CUI DEVICES

Product Change Notice (PCN)

PCN Number: PCN-0334008R-01

CMC-5044PF-A CURRENT

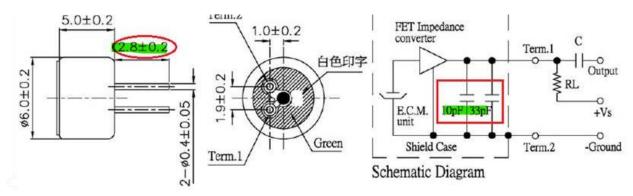
To ensure lead times are not being extended with shortage of material we have changed to a new PCB supplier and will be using a PCB with a 2.8 mm pin length and a 10pf + 33pf capacitator. Adding the two additional capacitors will be helpful on anti-interference at high frequency.
